CITY PLANNING COMMISSION

APPLICATION: A. Negative Declaration

B. Special permit to develop a 12,000 sq.ft, 400 seat church on a vacant 3.95+ acre lot in the Single Family (R-1) Zone.

LOCATION: Northwest Corner Valley Hi Drive / Center Parkway.

EXHIBIT B SITE PLAN

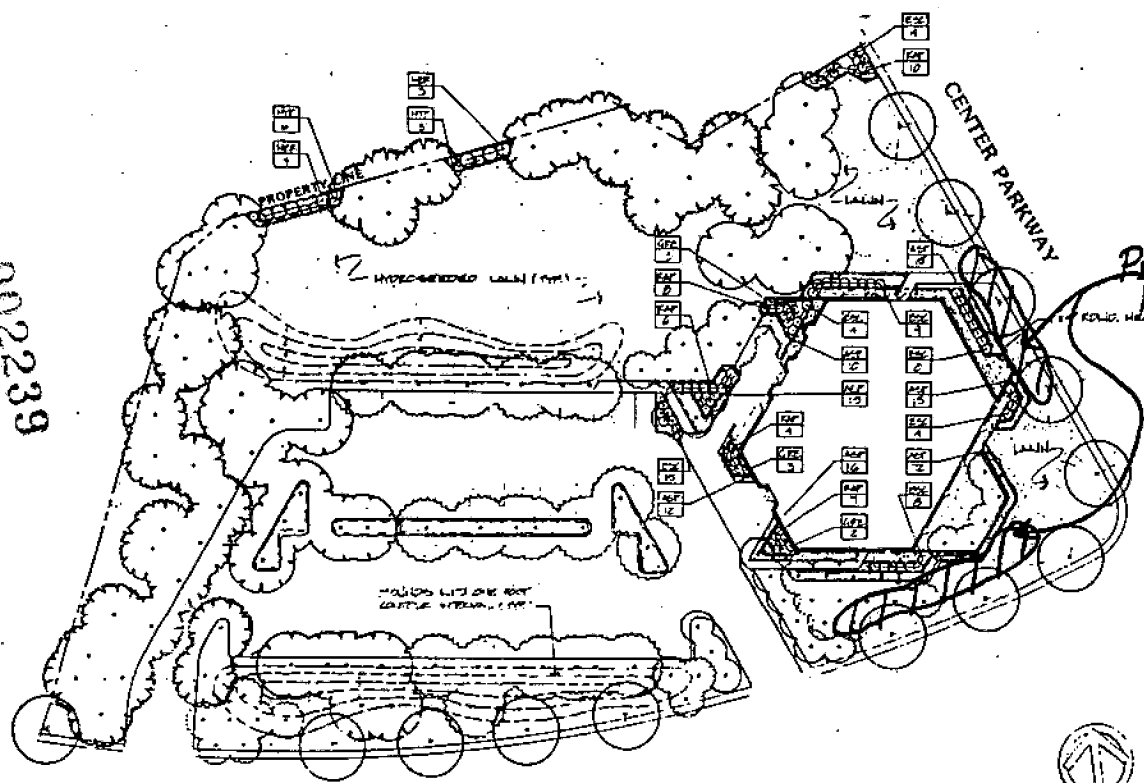
1. Setback - In reviewing the location of the building staff desired to increase the setback from Center Parkway greater than the 31 feet proposed. In redesigning the eastern driveway to satisfy the City Traffic Engineer's comments, the revised site plan shows the eastern driveway directly opposite Hollyhurst Way. This reduces the options in turning or moving the building to increase the setback off Center Parkway.

3. Parking - The proposed sanctuary will have 298 moveable seats with additional seating capacity of 90 seats in the narthex. A total of 65 parking spaces are required with 81 being provided as follows: 63 regular spaces; 15 compact car spaces; and 3 handicapped spaces. The city Traffic Engineer provided comments which affected the relocation of both driveways. He also indicated that the walkway should be moved away from the driveway entrance to discourage dropping passengers in the mouth of the driveway blocking the entrance. The revised site plan, Exhibit, reflects modifications suggested by the City Traffic Engineer.

5. Trash Enclosure: ⁰⁰²²²⁷ The applicant deleted placement of an area for refuse collection on the site plan. The project architect indicated the northwest wing wall would be able to be modified to include a screened and enclosed area for garbage cans or dumpster bin. A solid metal on wood gate is required for the trash enclosure area.

- C. The proposal was reviewed by the City Water Division, City Engineer and Traffic Engineer. Comments were received from the City Traffic Engineer which were addressed by the project architect in the revised site plan.

3. The revised landscape and irrigation plans are to be reviewed and approved by the Planning Director prior to issuance of building permits.
4. The applicant shall revise the site plan to reflect the inclusion of a trash enclosure area screened visually by the use of either solid metal or wood gates that meet the locational requirements of the refuse collection agency.

EXHIBIT C LANDSCAPE PLAN

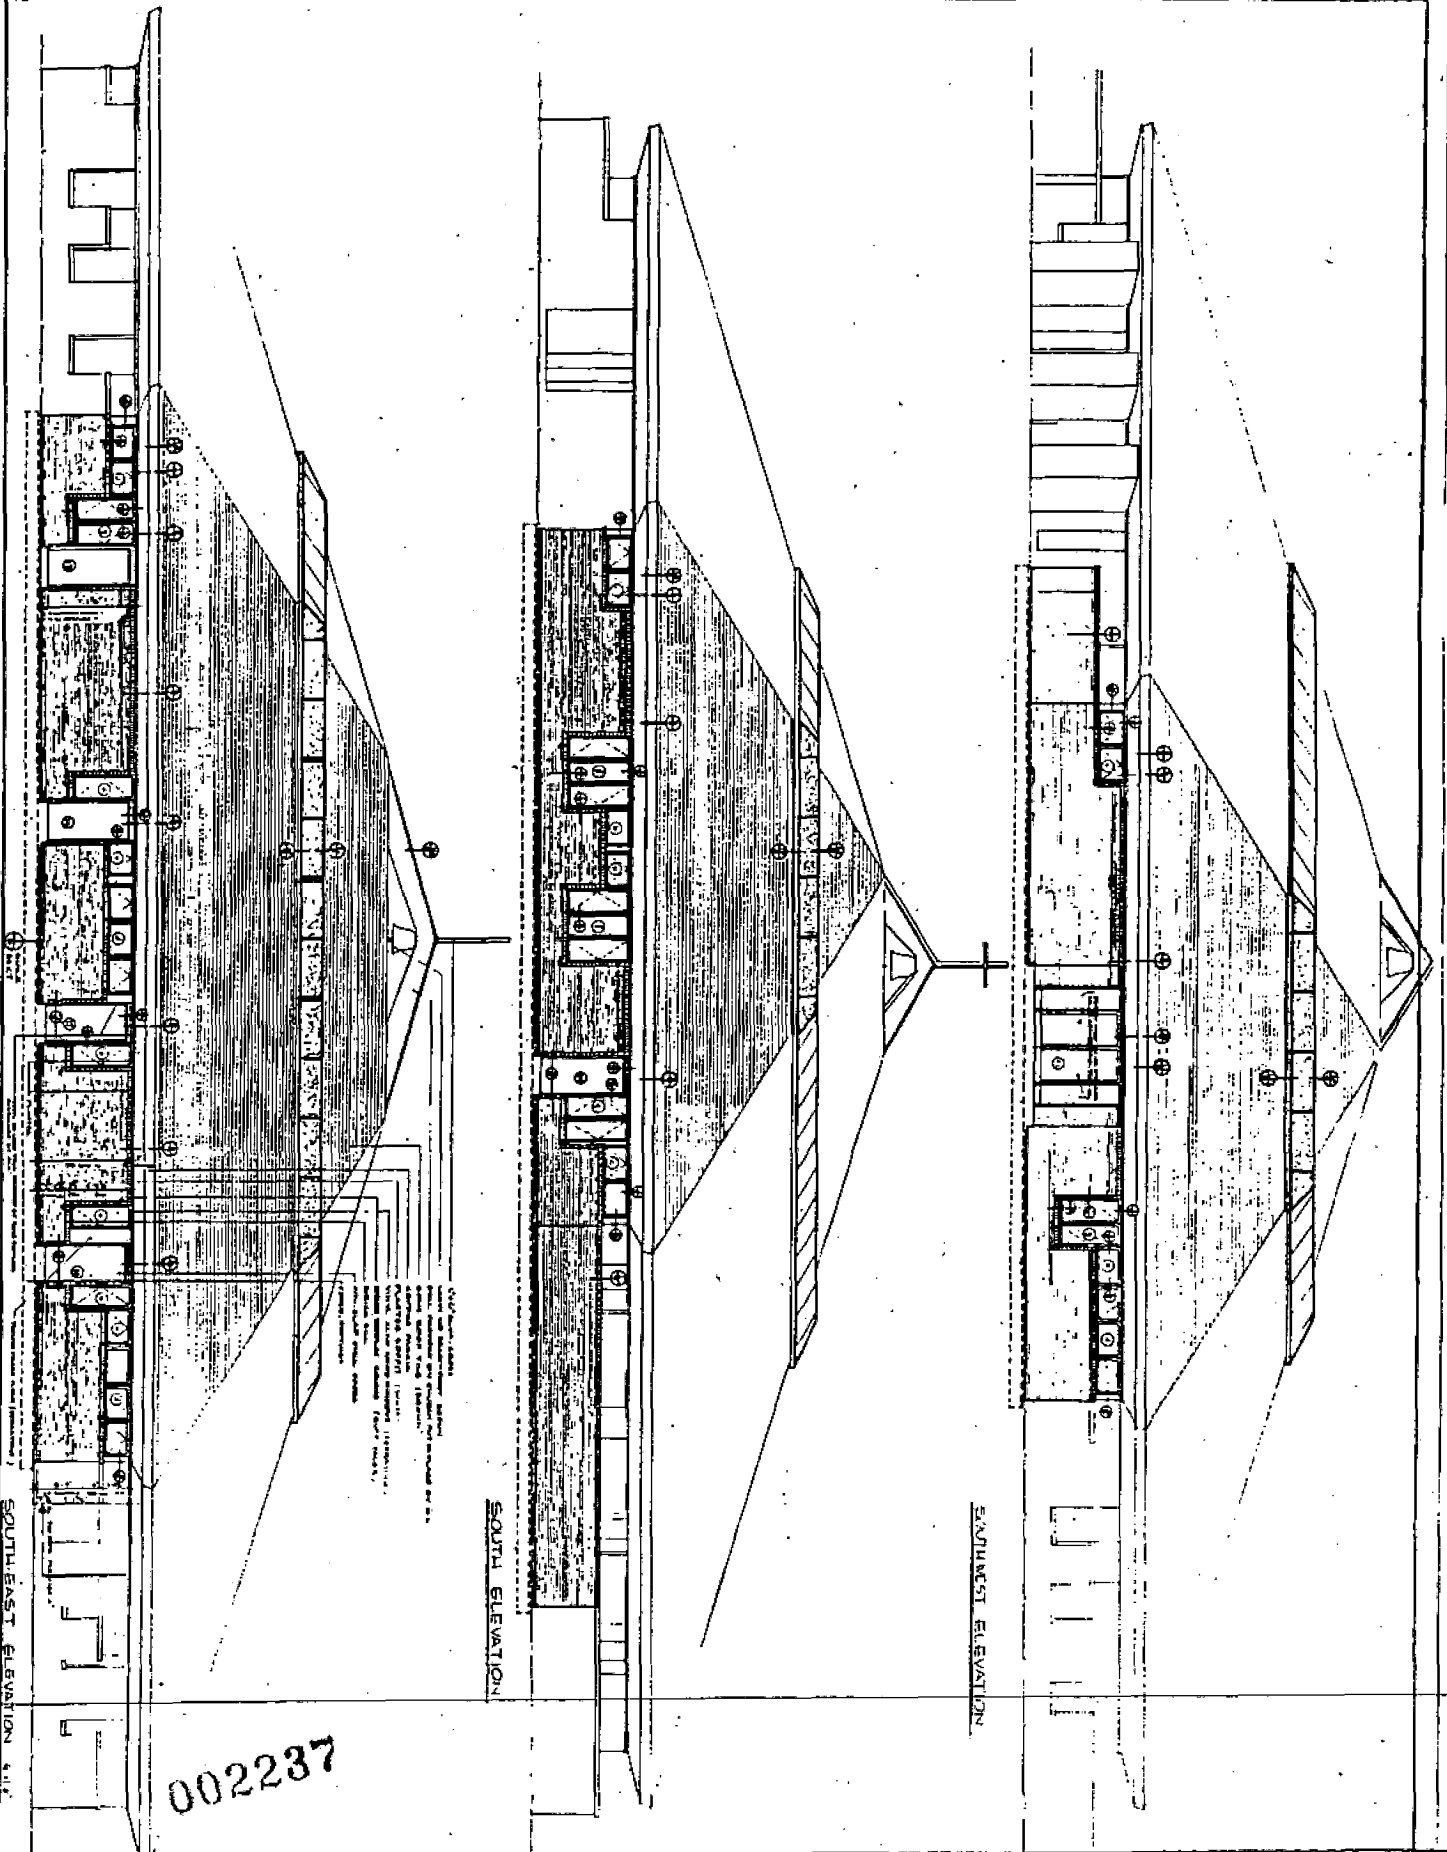
4. Landscaping - The entire site is proposed for extensive landscaping. The parking lot will be covered by 50% shade trees within 15 years of installation. Staff recommends that evergreen trees and shrubs be planted along the fence line. Presently the landscape plan shows a mix of evergreen and deciduous trees along the fence line. Staff also recommends that the setback area between the church and Center Parkway and Valley Hi Drive be landscaped to screen the wall by adding a berm of 3 to 4 feet in height supplemented by evergreen shrubbery to lessen the height difference as viewed from Center Parkway and Valley Hi Drive.

Proposed Staff Berm areas
BY KING, HEARD (CPL)

1. The applicant shall submit a revised landscaping plan showing landscaped berms (3-4' in height along Valley Hi Drive and Center Parkway between the property line and building and parking area.

2. The revised landscape plan shall indicate evergreen trees and shrubs (5-15 gals) along the fence separating the single family residences to the north from the subject site. Shrubs shall be planted along the parking stalls fronting on Valley Hi Drive to provide screening of vehicles.
